**ON-SITE SEWAGE DISPOSAL SYSTEM
 HOWARD COUNTY HEALTH DEPARTMENT
 BUREAU OF ENVIRONMENTAL HEALTH**

SUBDIVISION: Clarks Meadow LOT NUMBER: 8

ADDRESS: 3918 Clarks Meadow Drive PROPERTY OWNER: Douglas Homes

HOUSE LOCATION DRAWING

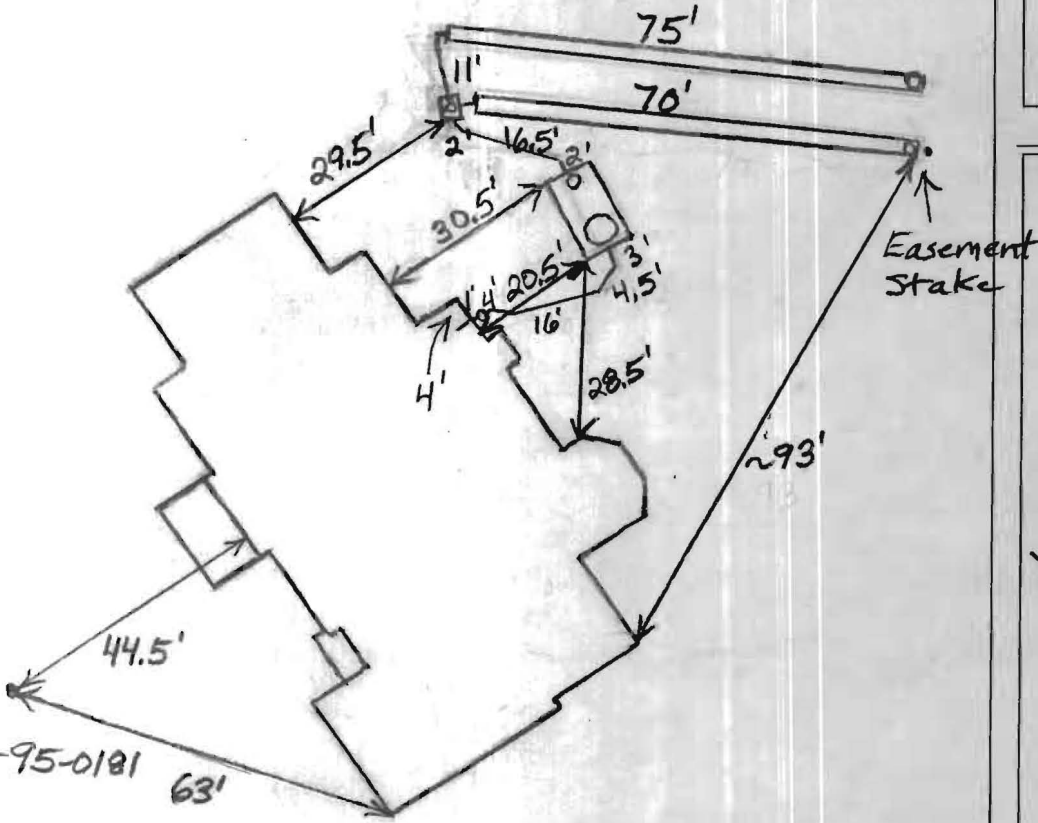
5/19/09 Install a 68' and 75' trench on contour across the top of the easement. Inlet 3.5' and bottom 6'. Keep tank 20' from house and 5' from top trench. (BB)

5/28/09 System finished. O.K. to backfill. (BB)
